UN Regulation No. 10 (Electromagnetic Compatibility)

Proposal for a new 07 series of amendments to UN Regulation No. 10 (Electromagnetic compatibility)

Submitted by the expert from by the Informal Working Group on Electromagnetic Compatibility*

"3.2.1. Applicability of this Regulation to ESA:

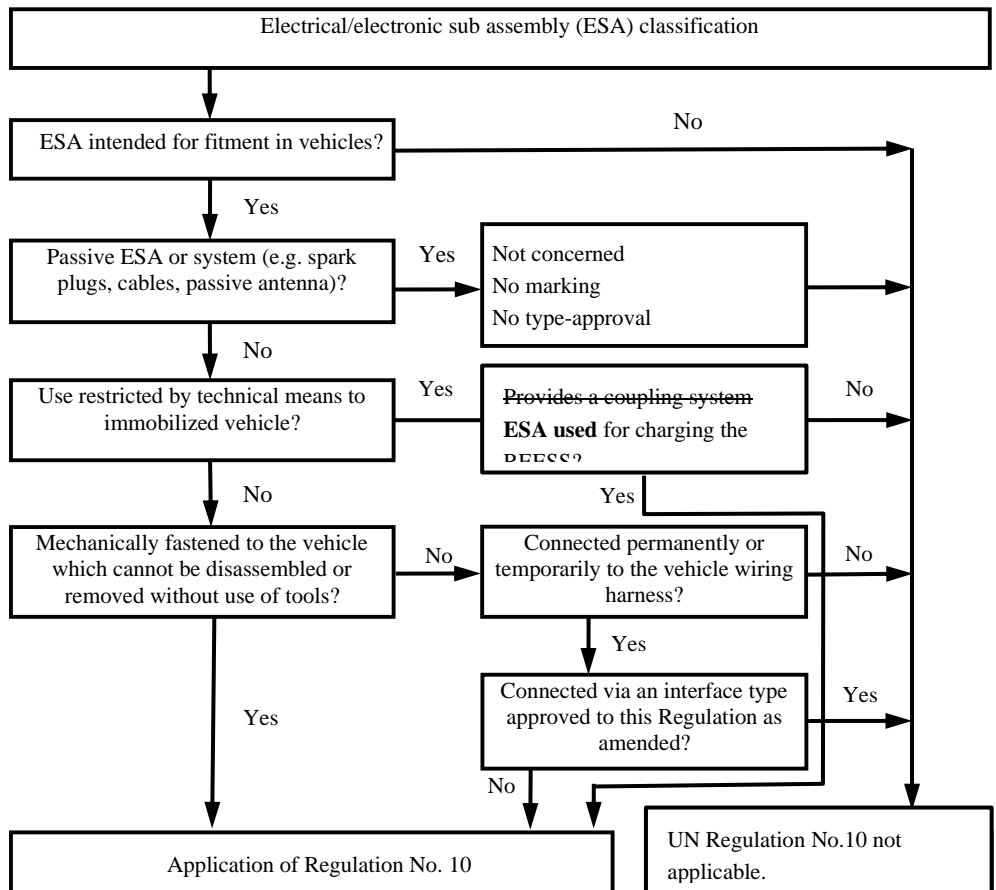
Paragraph 3.2.1., amend to read:

7. In paragraphs 2.31. and 2.32., the definitions of AVAS and AECS were included, because new failure criteria were added to Annex 6.
8. In paragraph 3.2.1., the flowchart was updated for clarification of the wording “coupling system”. Furthermore, it may be necessary to apply other EMC regulations if UN Regulation No.10 is not applicable.

"Figure 1

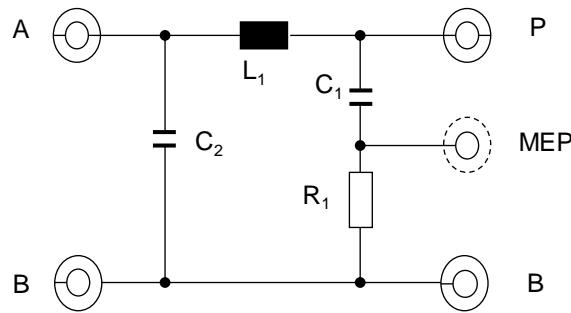
Paragraph 1., figure 1, amend to read:

"Figure 3

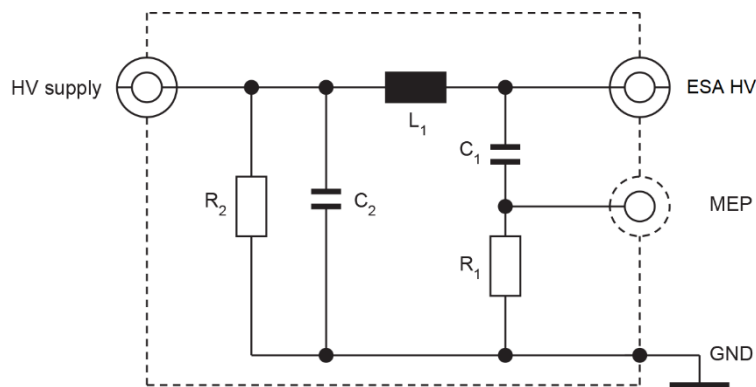
Paragraph 2., figures 3, 4 and 5, amend to read:

"Figure 4

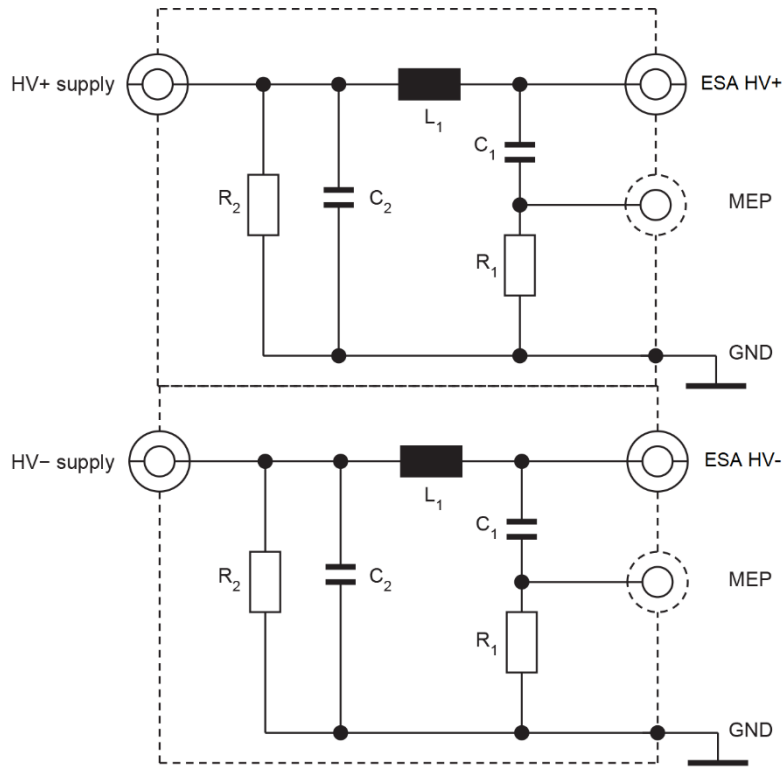
If unshielded HV ANs are used in a single shielded box, then there shall be an inner shield between the HV ANs as described in Figure 4."

"Figure 5

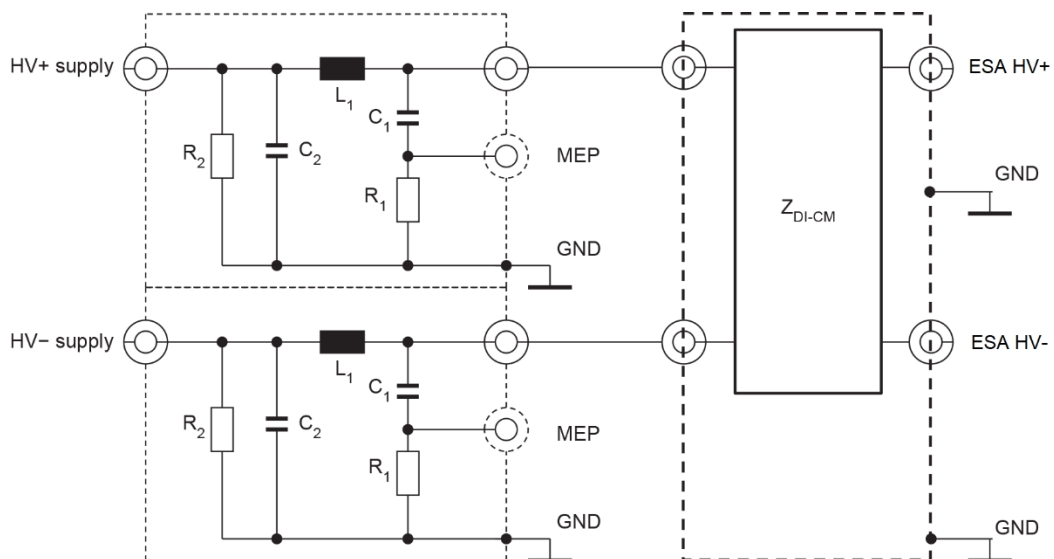
An optional impedance matching network may be used to simulate common mode / differential mode impedance seen by the ESA plugged on HV power supply (see Figure 5)."

Figure 1
Charging mode configuration for Annex 4

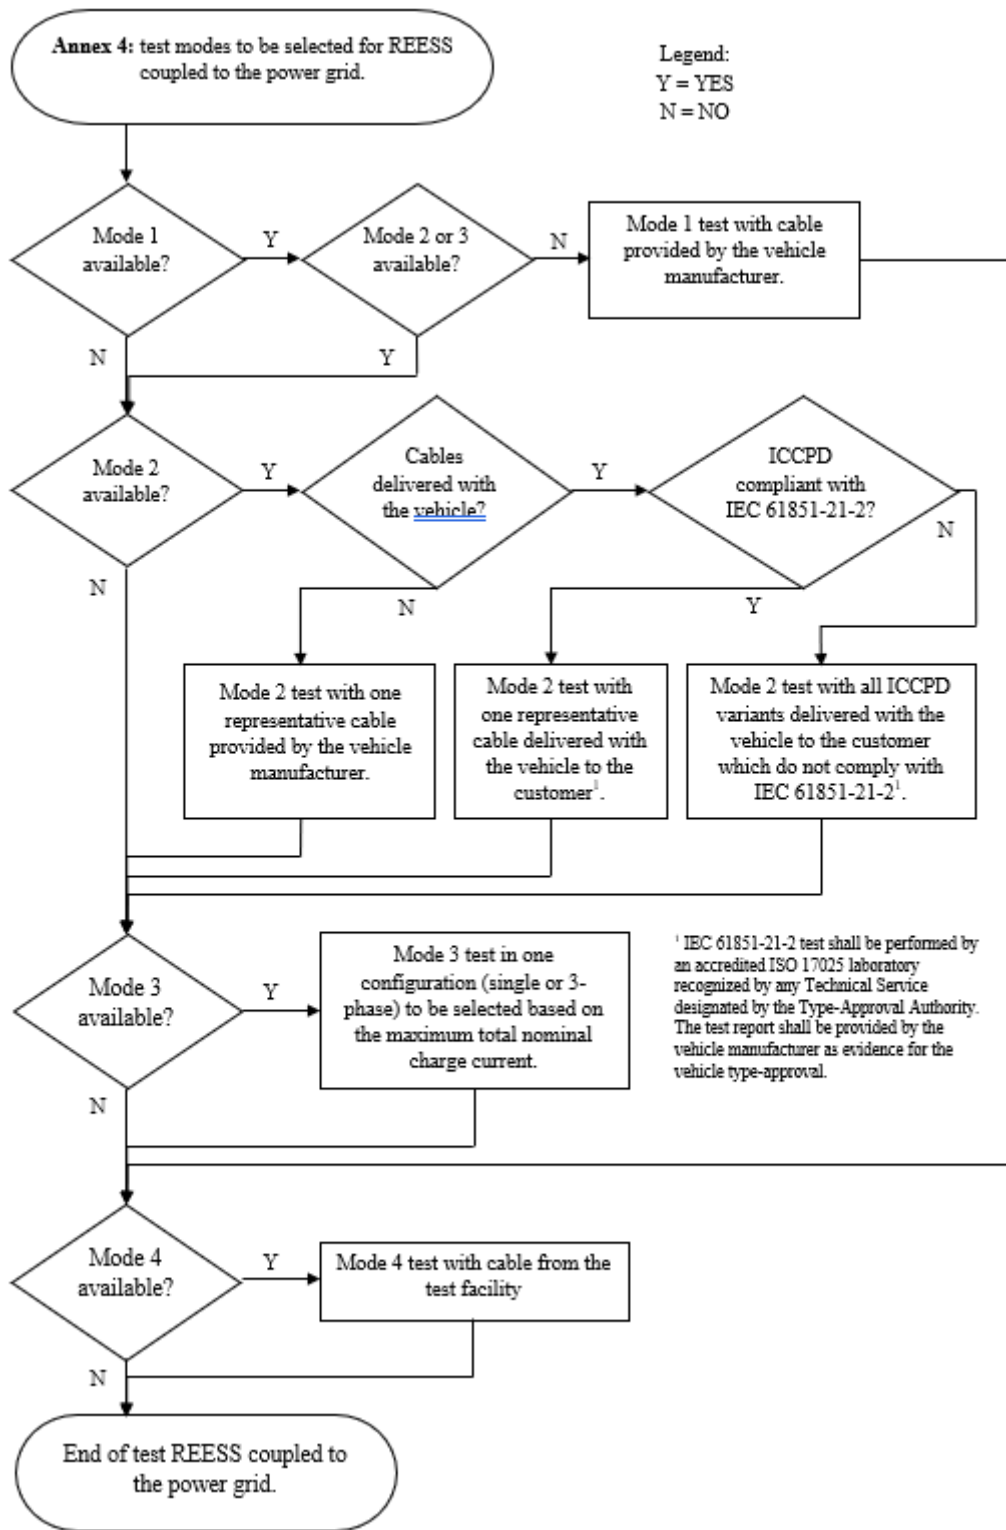
Paragraph 2.2., amend to read:

- "2.2. Vehicle in configuration "REESS charging mode coupled to the power grid".
The vehicle shall be tested in the charging mode configuration (if available on vehicle) as defined in flowchart of figure 1

Figure 3
Vehicle in configuration "REESS charging mode" coupled to the power grid:

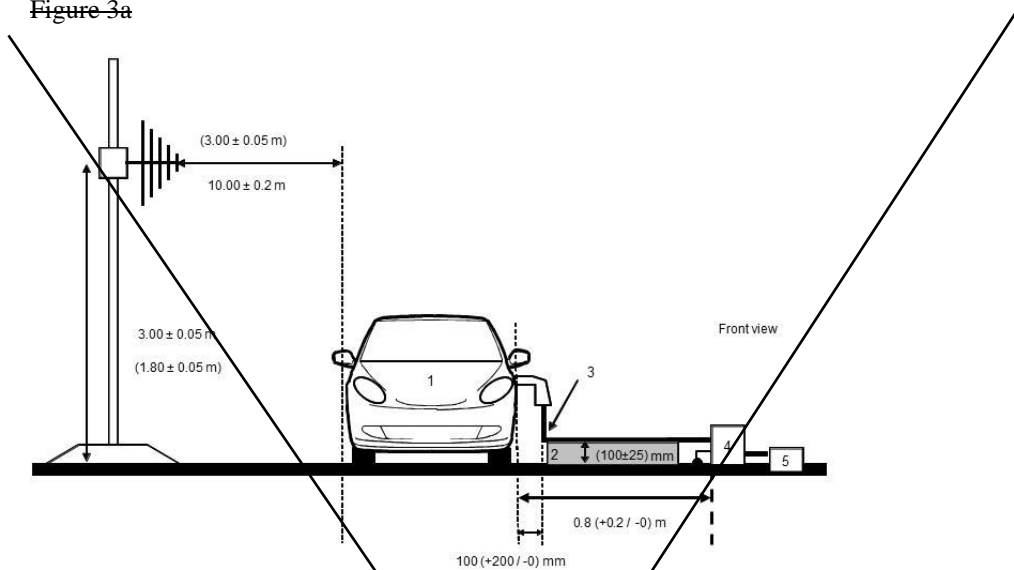
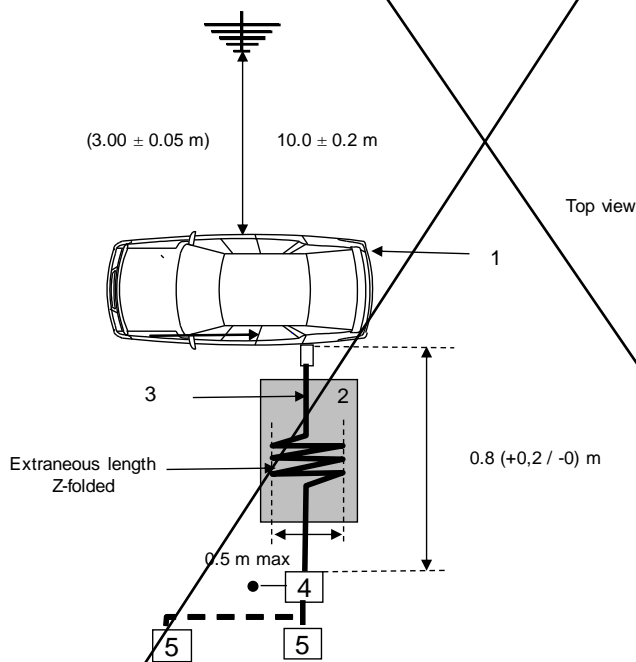
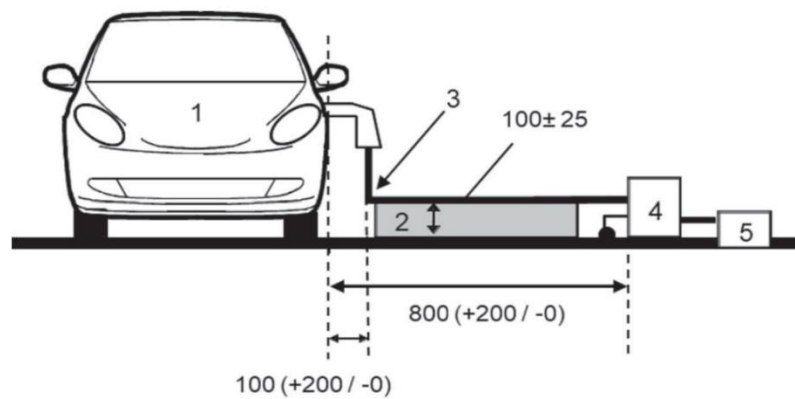
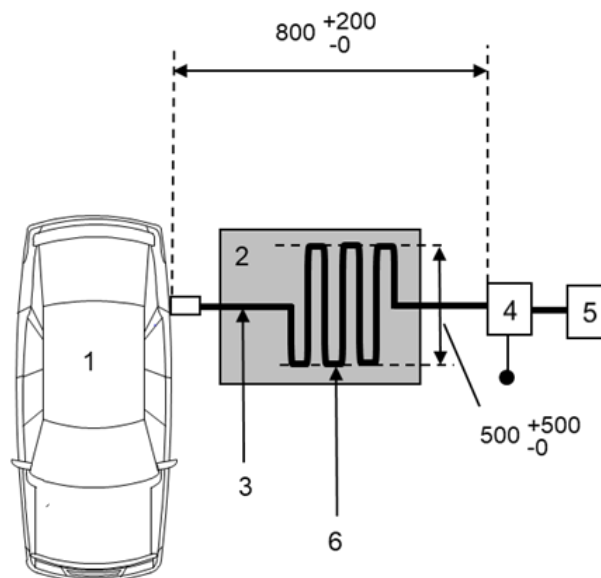
The power charging harness shall be placed in a straight line between the AMN(s) and the vehicle charging plug and shall be routed perpendicularly to the vehicle longitudinal axis (see Figure 3da and Figure 3c). The projected harness length from the side of the AMN(s) to the side of the vehicle shall be 0,8 (+0,2 / -0) m as shown in Figure 3db and Figure 3ed.

Figure 3e

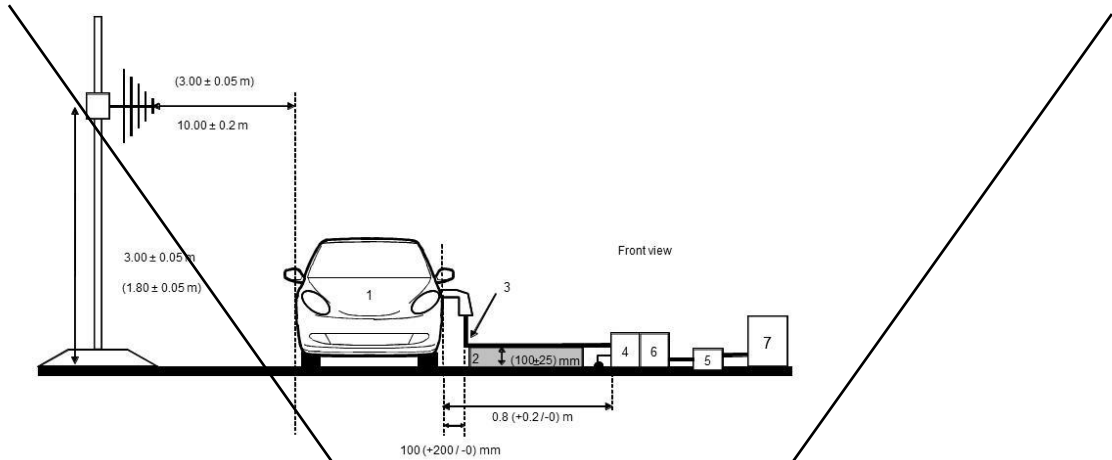
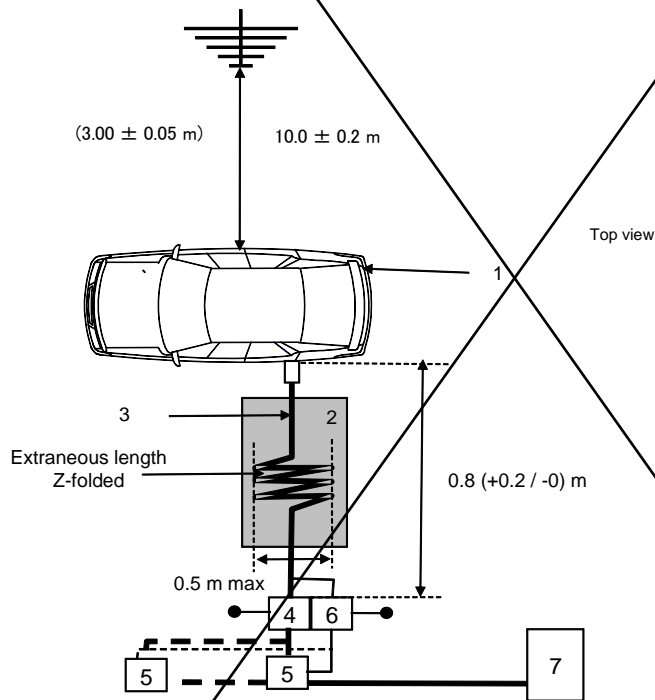
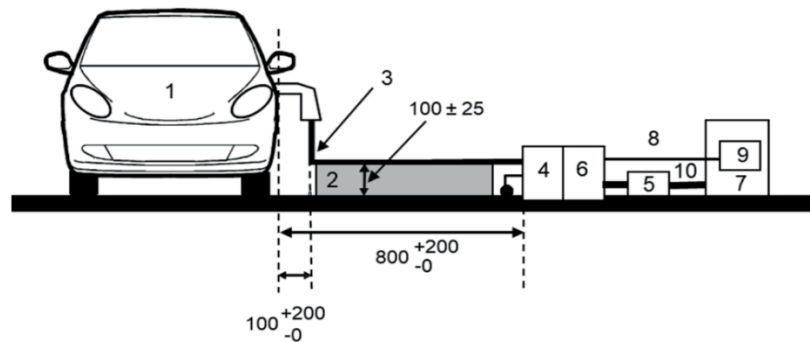
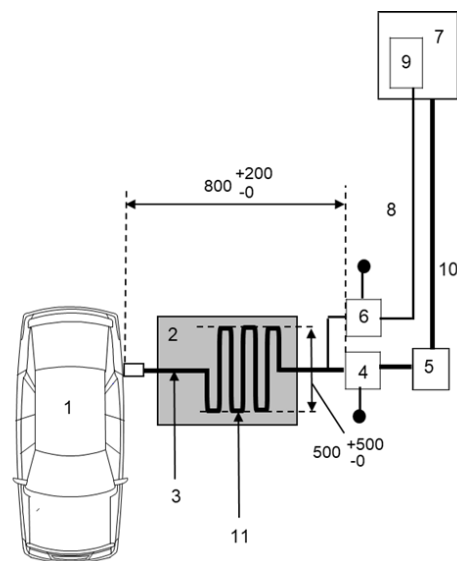
The power charging local/private communication harness shall be laid out in a straight line between the AMN(s) / DC-charging-AN(s) / AAN(s) and the vehicle charging socket and shall be routed perpendicularly to the vehicle’s longitudinal axis (see Figure 3fe and Figure 3g). The projected harness length from the side of the AMN(s) to the side of the vehicle shall be 0,8 (+0,2 / -0) m **as shown in Figure 3f and Figure 3h.**

Figure 1

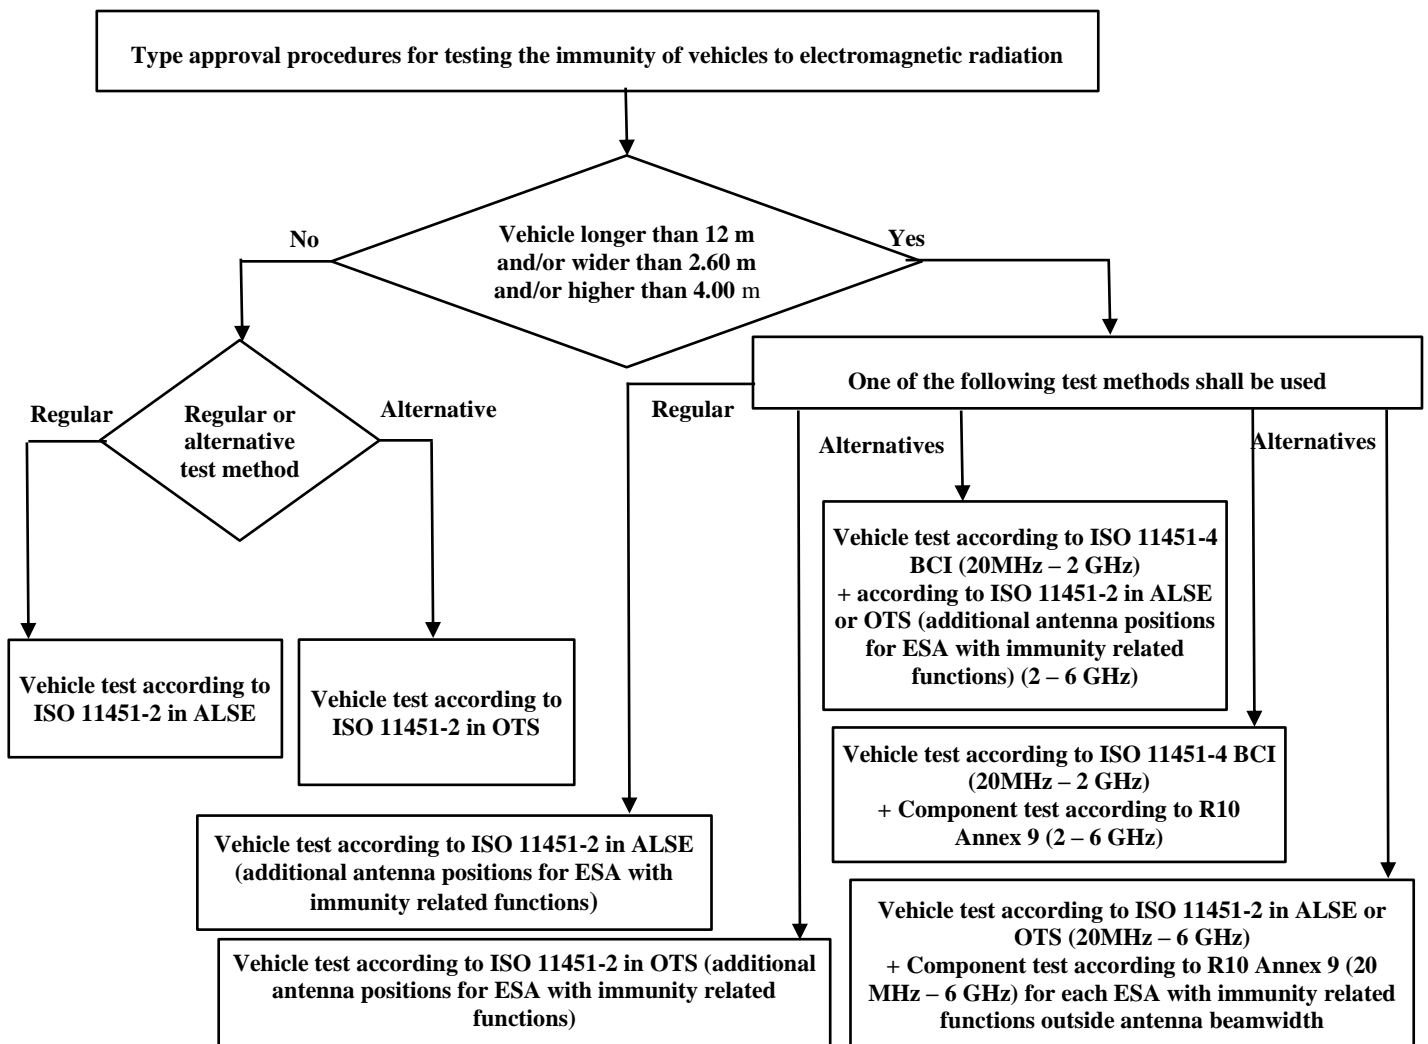
Insert a new paragraph 1.4., to read:

"1.4 Applicability of test methods:

16. In paragraph 6.8.2.1., the wording concerning ESA electromagnetic immunity test methods was replaced by two tables in order to give a better overview and to clarify the test severity and applicability of five different test methods in two frequency ranges.

Figure 2
Charging mode configuration for Annex 6"

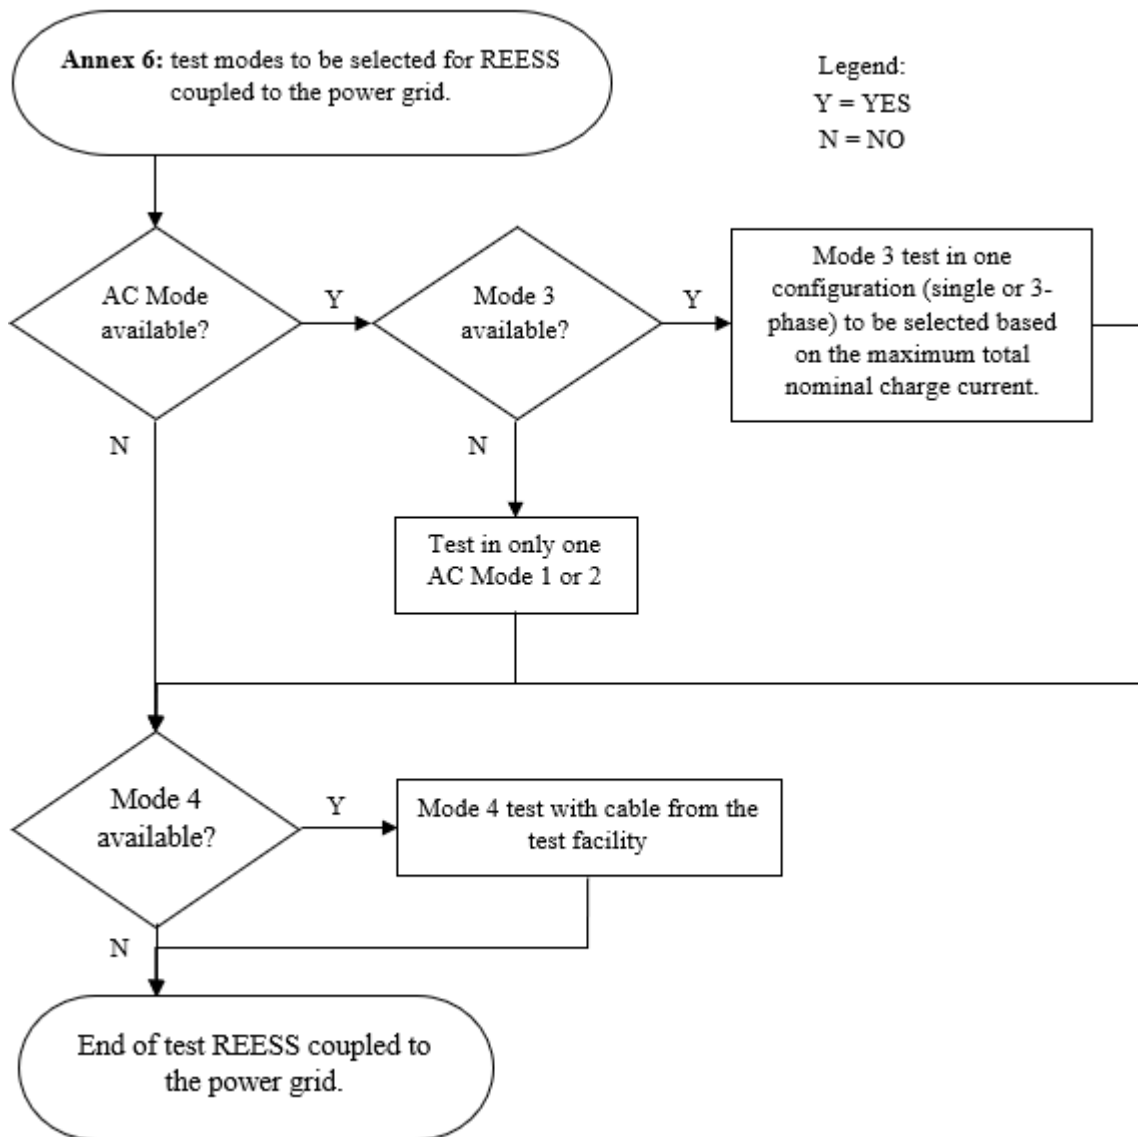
The vehicle shall be tested in the charging mode configuration (if available on vehicle) as defined in flowchart of figure 2
